67-F-4
W.P. # 642-64
KITCHENER -
WATERLOO
EXPRESSWAY
UNIVERSITY
AVENUE
UNDERPASS

FOUNDATION INVESTIGATION REPORT
For
Proposed University Ave. Underpass
Kitchener-Waterloo Expressway
District #4 (Hamilton)

SUBJECT: University Avenue Underpass
Kitchener-Waterloo Expressway (Dryden Blvd.)
W.P. 642-64, Site No. 33-242
W.J. 67-F-4, District No. 4

SUBJECT: University Avenue Underpass
Kitchener-Waterloo Expressway
W.P. 642-64, Site 33-242
W.J. 67-F-4, District No. 4

UNIVERSITY AVENUE BRIDGE
U.P. 642-24
PRELIMINARY SKETCH FOR DESIGN

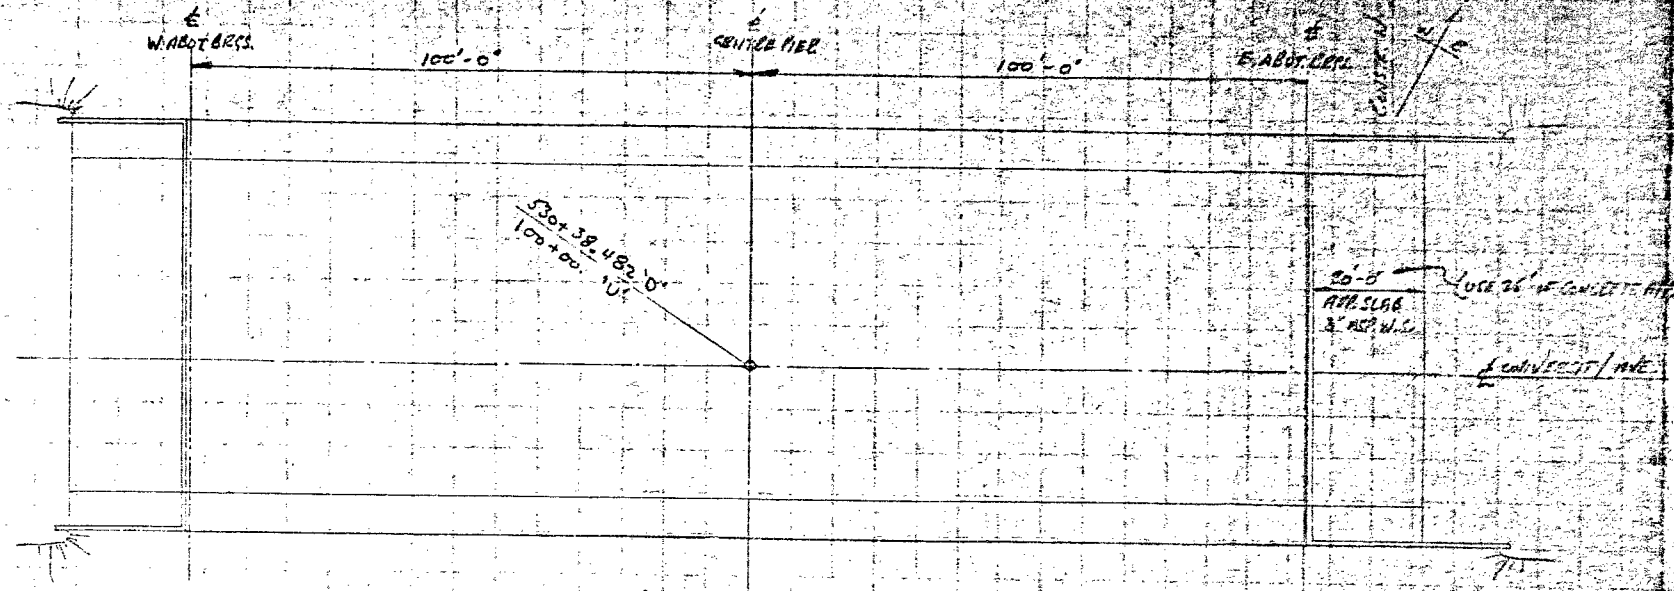
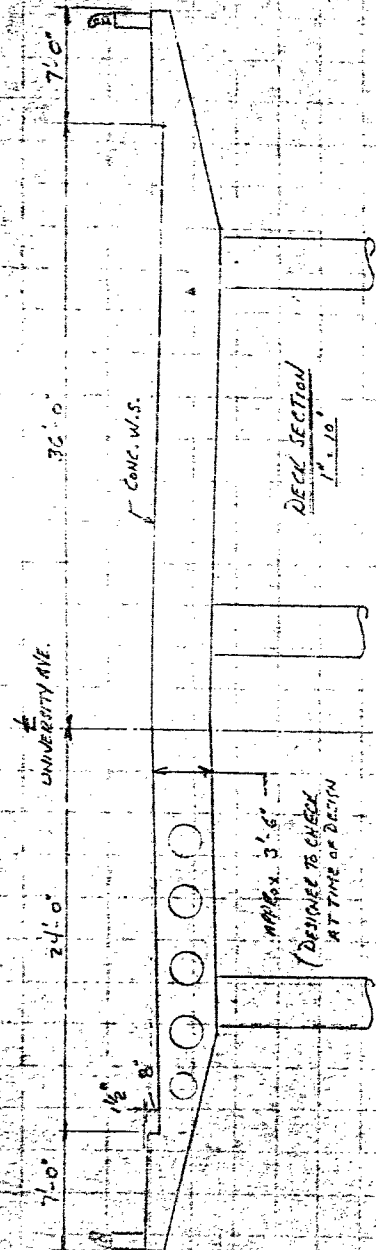
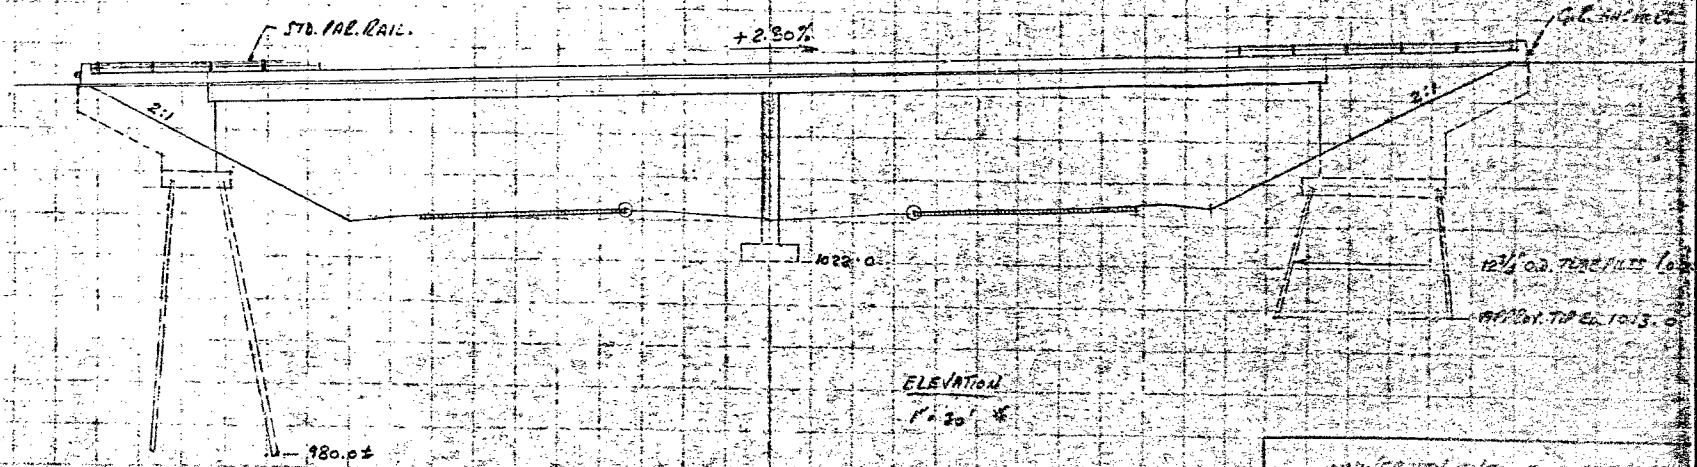
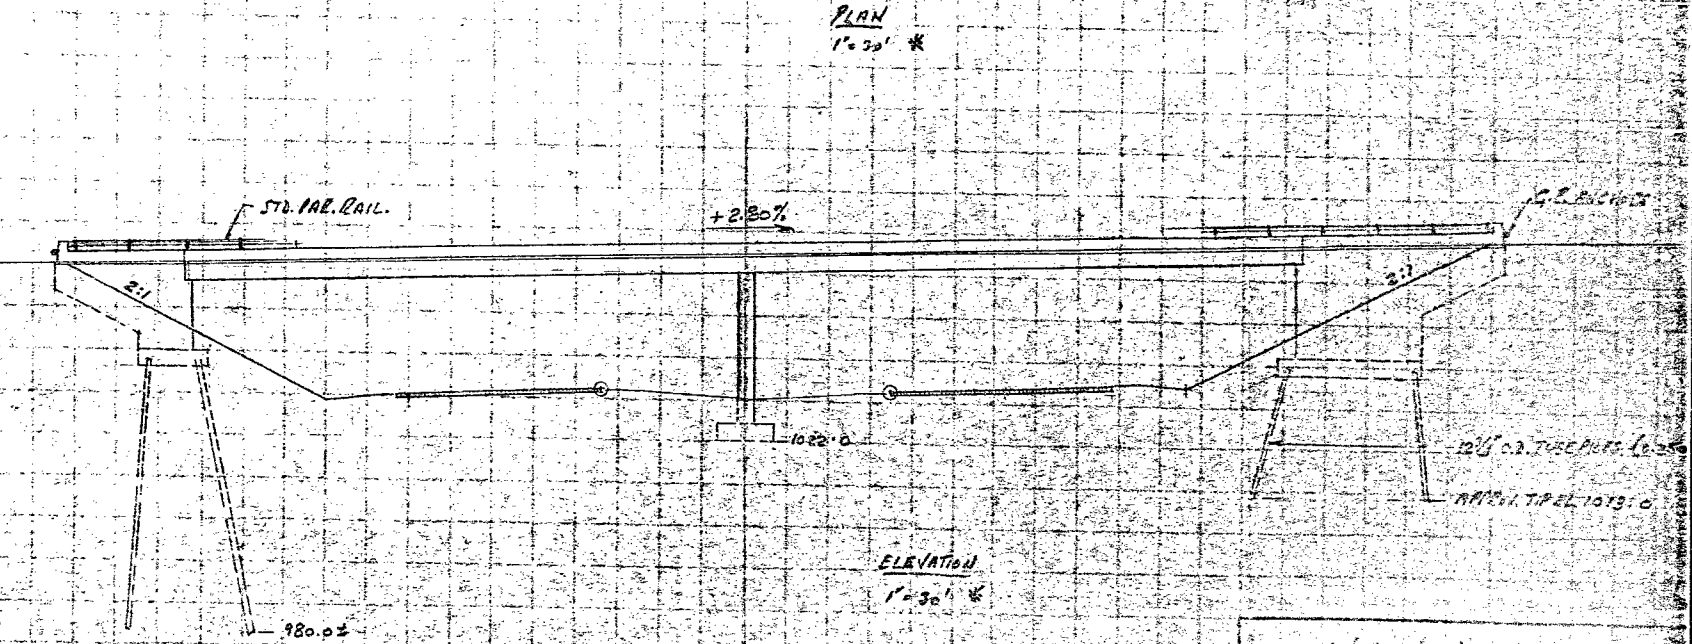
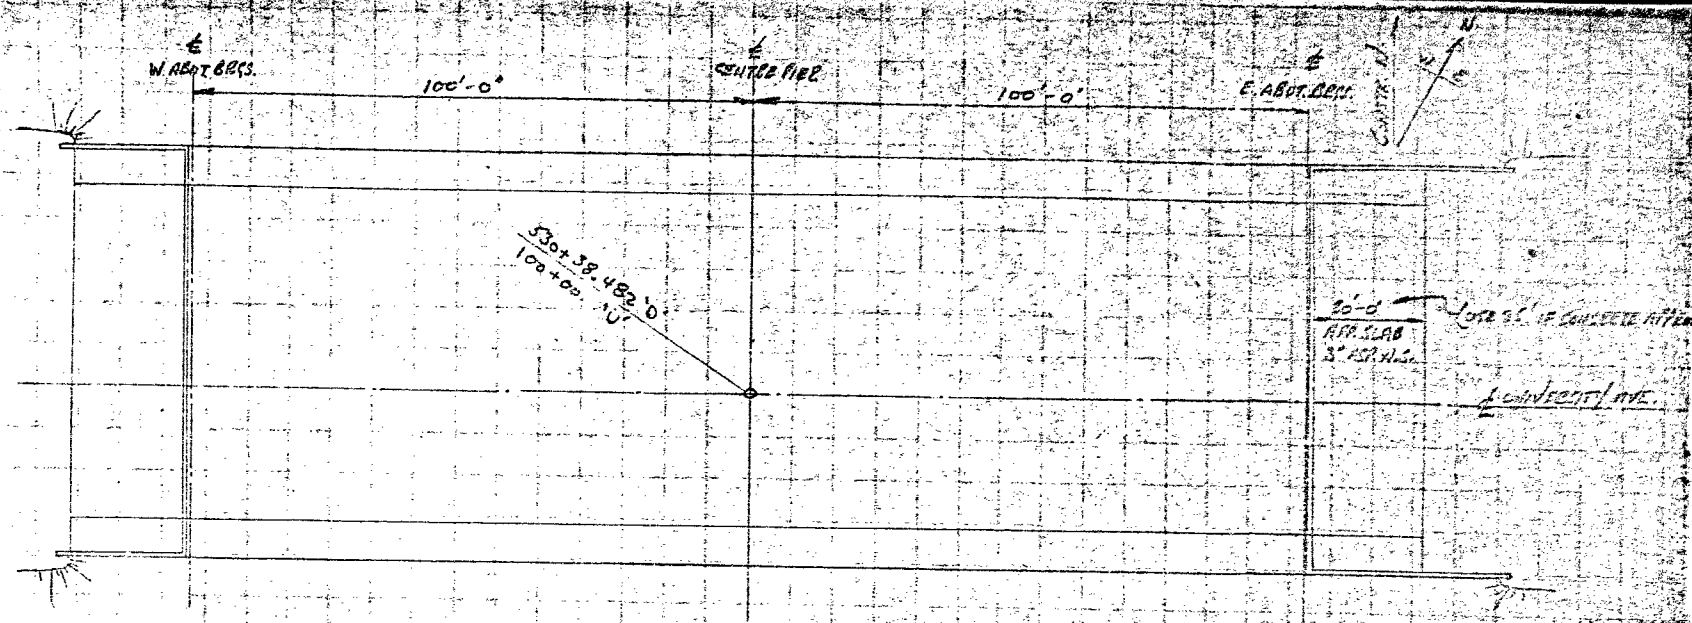
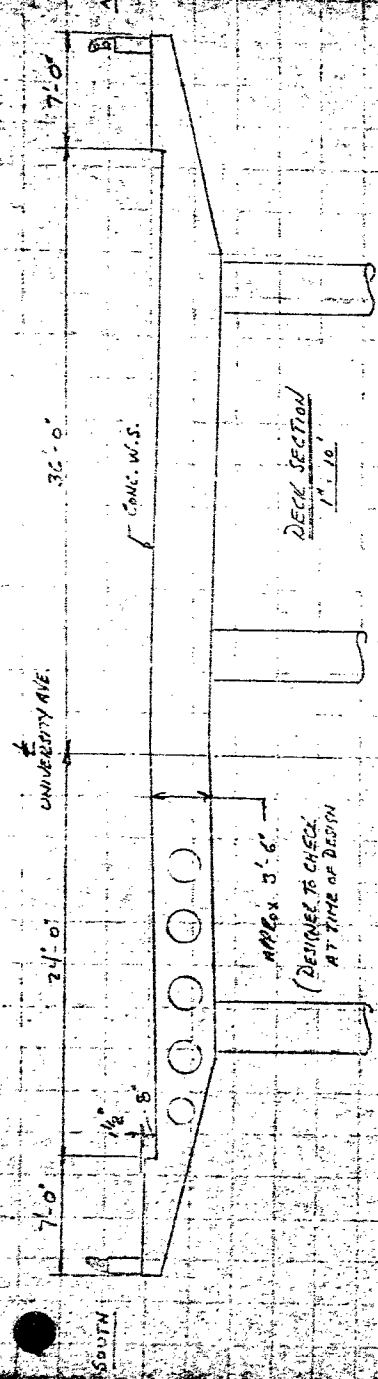
Would you please review the recommended tube pile tip elevation given in the Soils Report for the above structure, i.e. elevation 980.0 for the West Abutment. There is considerable doubt in my mind that the elevation of 980.0 will be reached. I would expect that the west abutment piles could be terminated well above this for a 45 ton design load, possibly at elevation 1005.0 considering the relatively high values for "N" between elevations 1000 and 1010.

Our proposed structure arrangement is shown on the enclosed sketch.

Following your memo of June 16, 1967, we have reviewed our recommendations regarding pile driving at the west abutment of the above mentioned structure. Above el. 983.0 + the subsoil consists of very stiff to hard silty clay: past experience has shown that

- (1) such material does not provide high end bearing for piles;
- (2) the support provided by friction is not easy to predict; and
- (3) the capacity of piles within such a layer cannot be predicted by means of a dynamic pile driving formula and, in fact, is usually grossly overestimated.

We are of the opinion that the piles should be driven into the much coarser-grained and less plastic clayey silt layer which occurs below el. 983.0 +. It is believed that satisfactory end-bearing support will be achieved in this case.
